CITY OF PORTLAND ENVIRONMENTAL SERVICES

M E M O R A N D U M

RE: Residential Infill Project

DATE: March 6, 2020

Figure 2 – Stormwater system areas

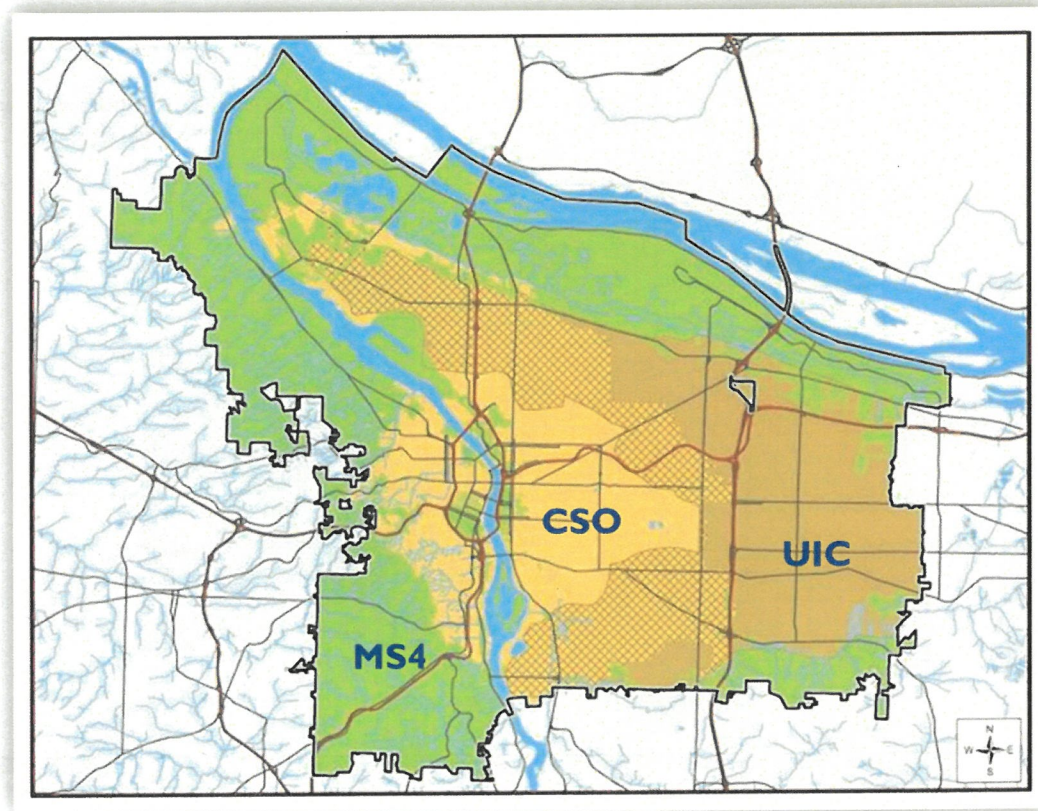
As shown in Figure 2, the east, west, and north portions of the city are served by separated sanitary and storm sewer systems (green shaded areas). The central portions of the city are generally served by combined sanitary and storm sewers (tan shaded areas). Large portions of the city on the east side of the Willamette River utilize Underground Injection Control (UIC, brown shaded areas) systems to infiltrate stormwater into the ground, thereby reducing runoff. The cross-hatched areas are served by both combined and UIC systems.

Figure 3 – Residential Infill and UIC Areas

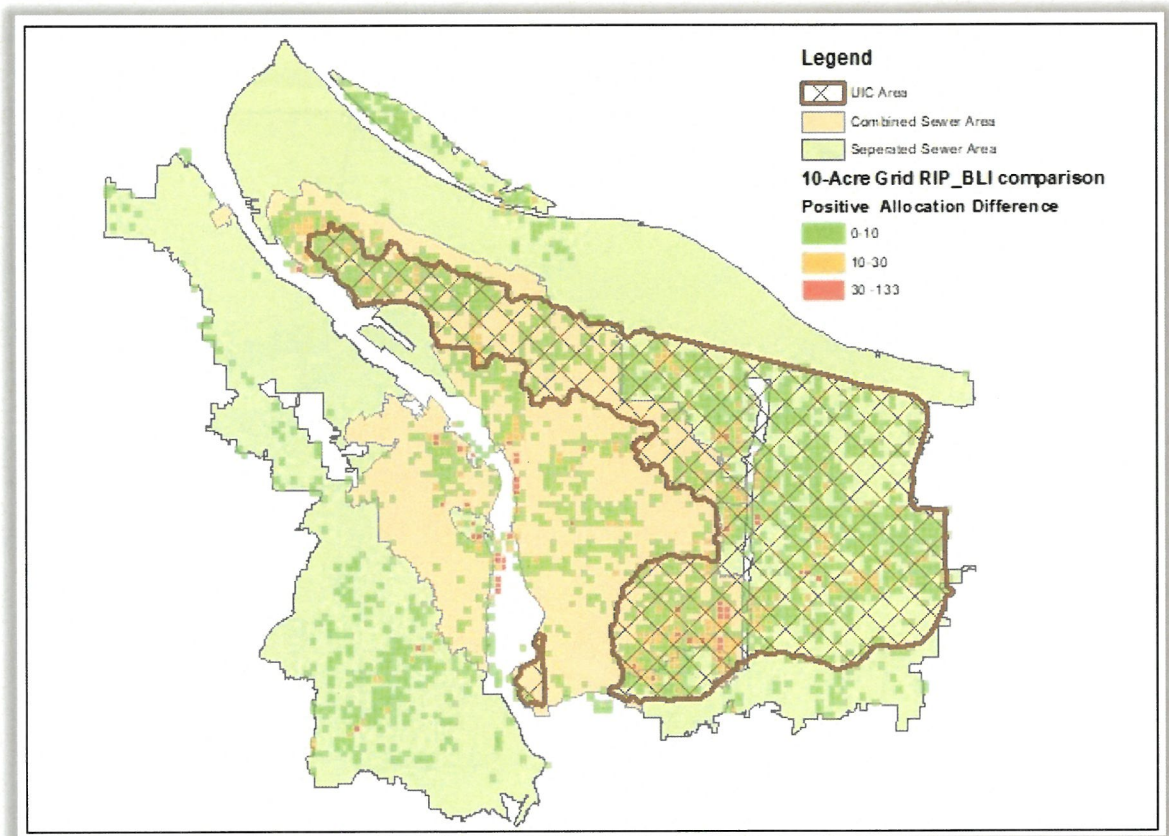
The City of Portland’s 2035 Comprehensive Plan Citywide Systems Plan (CSP) identified that some areas in the combined system are affected by localized hydraulic capacity limitations that increase the risk of basement sewer backups and/or street flooding. These areas are concentrated close in on the east side with scattered areas in other parts of the system. A number of projects to address this hydraulic deficiency were included in the proposed Investment Strategy in the CSP.² BES does not anticipate that the RIP proposal will cause an increase in the combined sewer hydraulic capacity limitations identified in the CSP. Sanitary flow is a minor component in the combined system when compared to stormwater flows, and much of the projected infill is within the UIC boundary where the sewers and wastewater treatment facilities tend to have excess capacity, and stormwater runoff from future development can be infiltrated into the soil (Figure 3).

BES has already identified a series of projects in the CSP Collection System Investment Strategy to address capacity deficiencies in the combined system over the next 20 years.³ Any contribution to these deficiencies caused by the additional densities allowed through the RIP will be addressed through these planned projects. BES employs an asset management model and continuously monitors the capacity of the combined system, constructing capital improvements to mitigate flooding risk and to limit combined sewer overflows in compliance with the City’s regulatory permits⁴. BES will continue this practice as residential infill and other development activity occurs. Therefore, BES has concluded that the combined sewer system, with planned projects included in the adopted CSP, is adequate or will be adequate to accommodate the forecasted growth from RIP.

Figure 4 - Heat map of areas that may not have access to stormwater service

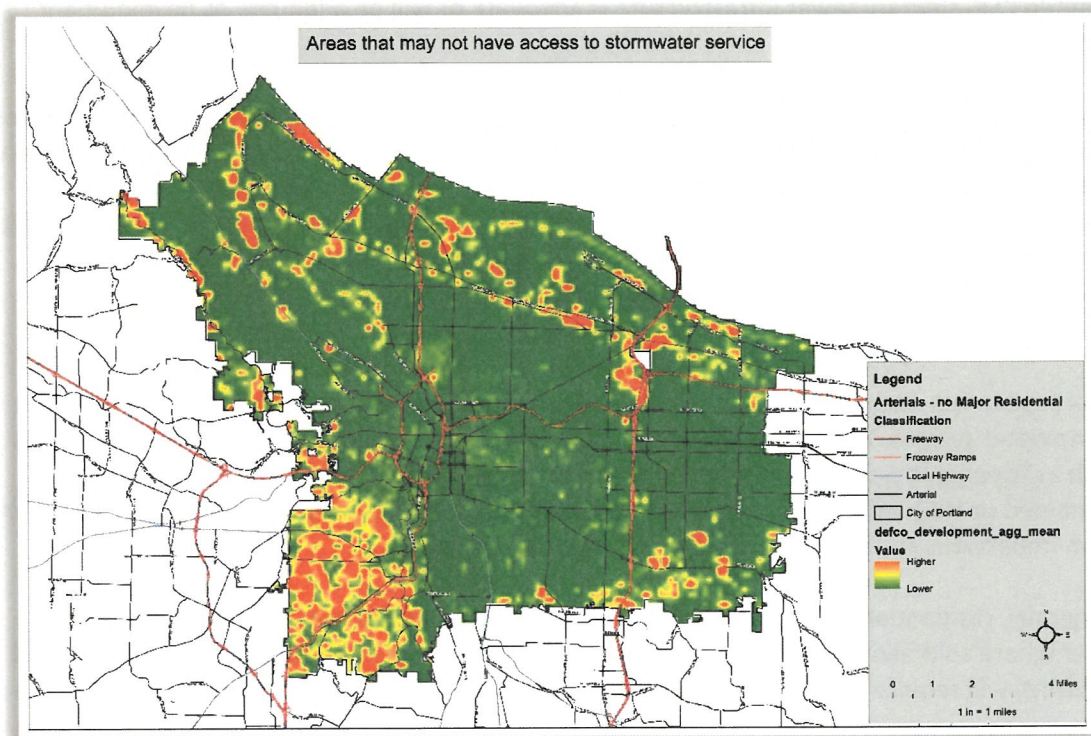
Our spatial analysis shows that approximately 6% of the residentially zoned taxlots within the RIP boundary likely do not have adequate stormwater service. Extending or providing service to these taxlots can be challenging, both from a financial perspective and because construction of service extensions can create ancillary needs, such as downstream capacity upgrades and roadway development (e.g. adding curbs and inlets). Typically, when a development application is reviewed and it's determined that service is not available, the burden is on the developer to extend the stormwater service or wait until BES plans, designs and implements a Capital Improvement Project to provide the needed service. Figure 4 is a heat map of existing taxlots which, based on our spatial analysis, have a higher likelihood of inadequate stormwater service.

Figure 5 - BLI Heat Map

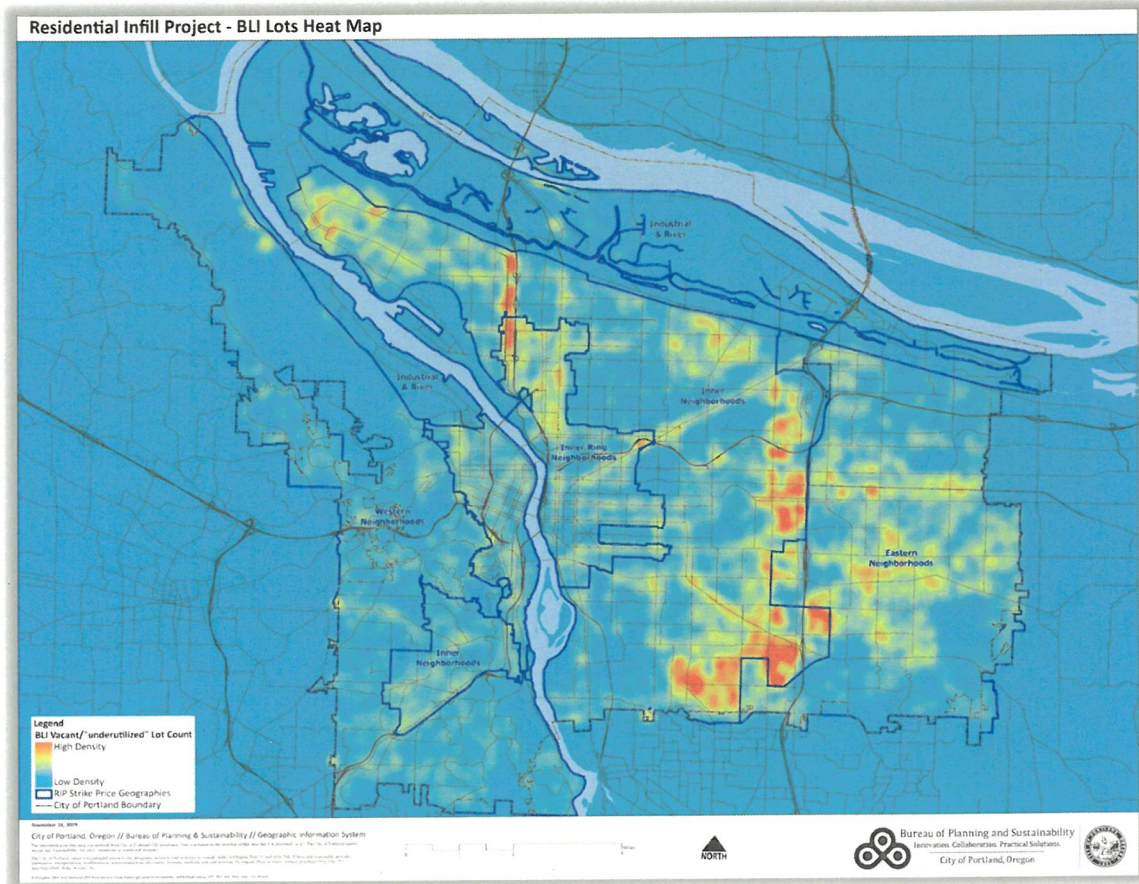
Many of the neighborhoods with challenging soils and topography are located on Portland’s west side. However, RIP models project a decrease in likely residential development on the west side. The BLI allocated 4,172 units to single family zones in the western neighborhoods. The RIP household allocation model predicts 2,509 units, a difference of 1,663 units or about a 40% reduction of households. About 1200 of the units are removed from lower density residential zones (R10, R20, RF) where stormwater and sewer services are even more challenging, and roughly 400 of the units are removed from RIP zones. These reductions are offset by increased households in inner and eastern neighborhoods, where stormwater systems are adequate, as a result of increased zoning capacity in those areas (see Figure 5).

This combination of reduced predicted allocation on the west side and smaller allowed FAR and building coverage results in a neutral impact on the current separated stormwater system. Any localized deficiencies will be addressed at the time of development or through capital projects identified in the adopted CSP⁶.
